Access Compliance Report Public Rights-of-Way (Pedestrian Signals)

Main Street: **ORANGEWOOD_AVE** Cross Street: **DALE_ST** Location: **SW**

ADA ID: **SGRK210927181510** Signal Type: **One Push Button-Non APS** Overall Compliance: **No** Severity Scores: **BTN 1: 35** **BTN 2: N/A** **No BTN: N/A**

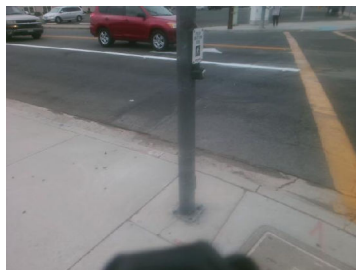
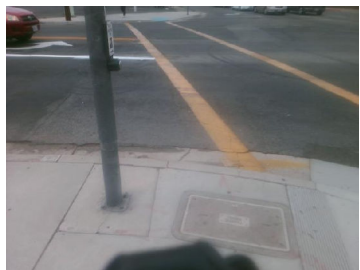
OC Std/PROW: **R404.2, R404.3, MUTCD 4e.08**

Possible Solutions: Replace Signal Push Button With APS Button. Remove and Replace Clear Space.
